OPERATION AND SERVICE MANUAL

8447D

AMPLIFIER

MANUAL PART NUMBER 08447-90033

Figure 11. 8447D/E/F Cabinet Parts

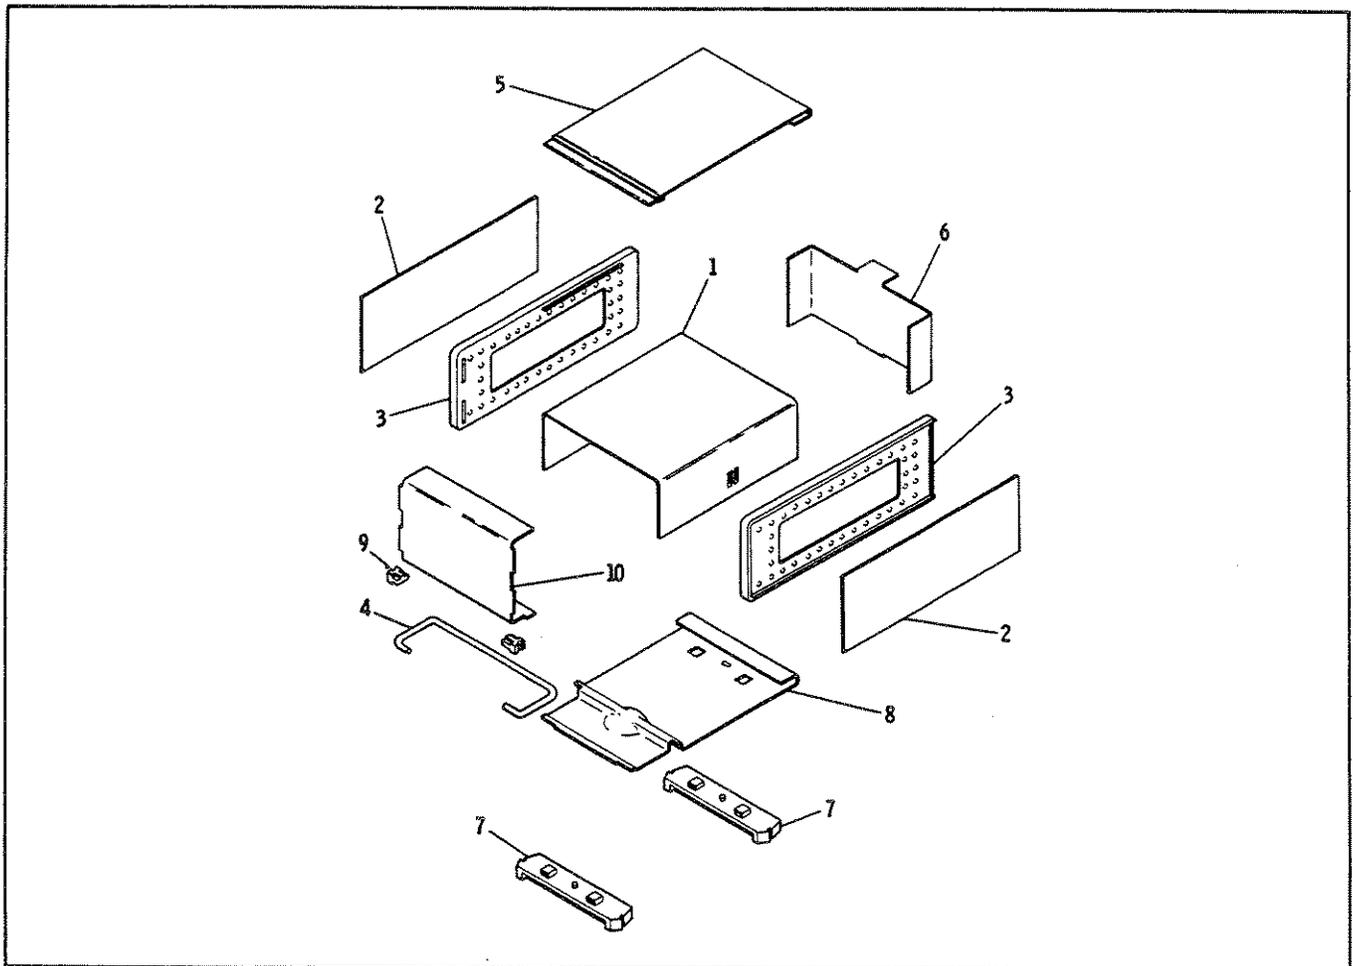
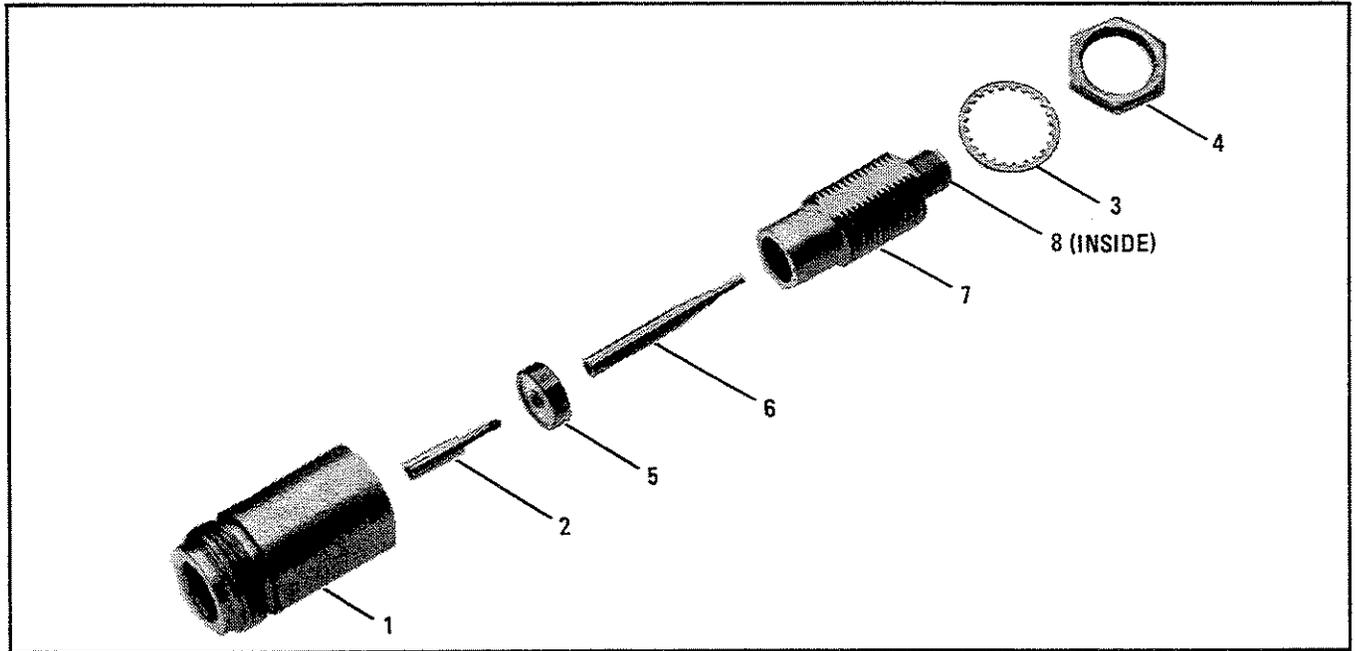
Page 24, Figure 11:

Change Index Number 6 to HP Part Number 08447-00002, Check Digit 3, PANEL REAR, Qty 1.

Page 24, Figure 11:

Delete HP part numbers 08447-00017, 08447-00018, 08447-00019, 08447-00021, 08447-00022, 08447-00023, 08447-00024, 08447-00025, 08447-00040, 08447-00041, 08447-00042, 08447-00043, 08447-00044, 08447-00045, 08447-00046, and 08447-00047 from Index Number 10.

Add to Index Number 10:

Page 24, Figure 11:

Delete HP part numbers 08447-00058, 08447-00059, 08447-00060, 08447-00061, 08447-00064, and 08447-00065 from Index Number 10.

Add to Index Number 10:

Page 24, Figure 11:

Delete HP part numbers 08447-00058, 08447-00059, 08447-00060, and 08447-00061 from Index Number 10.

Add to Index Number 10:

Page 24, Figure 11:

Delete HP part numbers 08447-00064 and 08447-00065 from Index Number 10.

Add to Index Number 10:

FIGURE 14. A1 POWER SUPPLY, COMPONENT LOCATIONS (ERRATA)

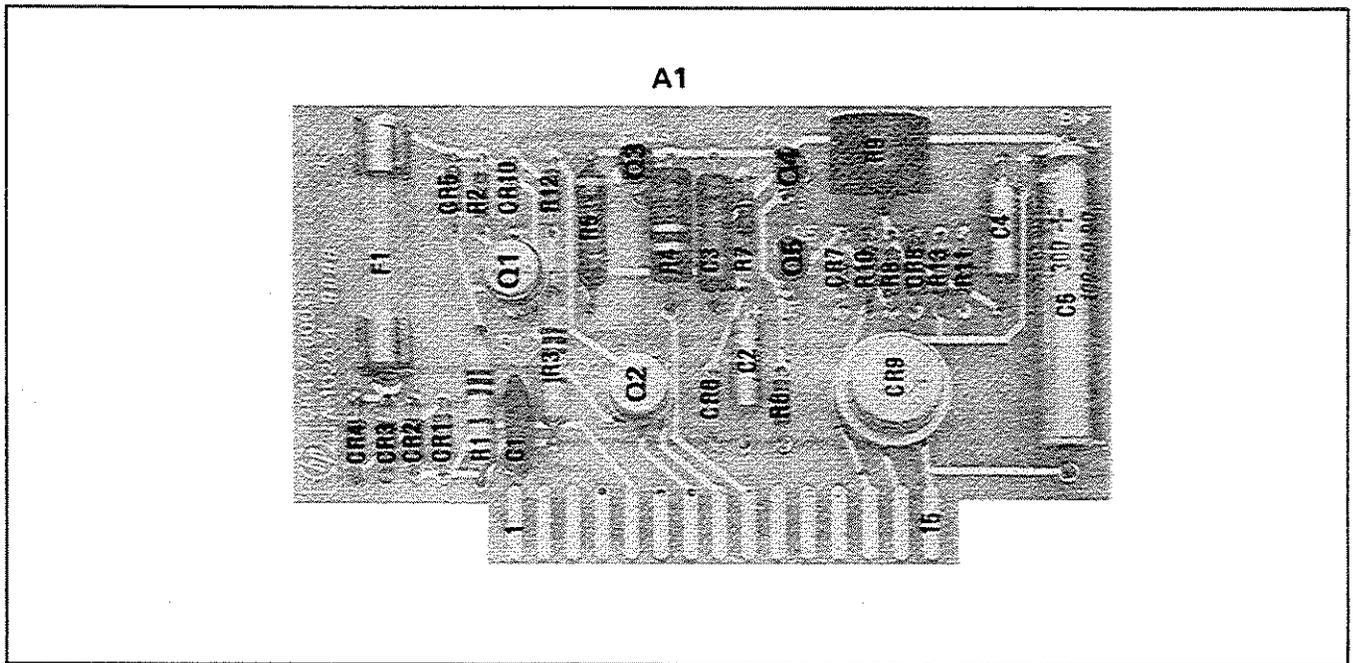
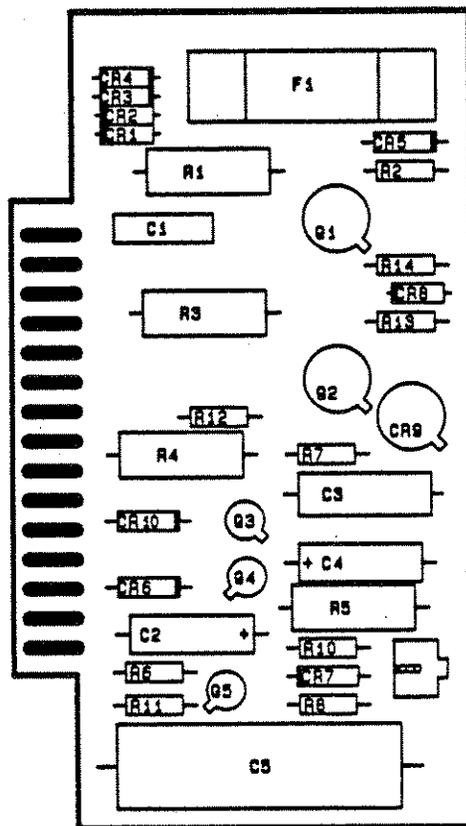
Page 27, Figure 14:

Replace Figure 14 with the new Figure 14, All Power Supply Component Locations (ERRATA), included in this Manual Changes supplement.
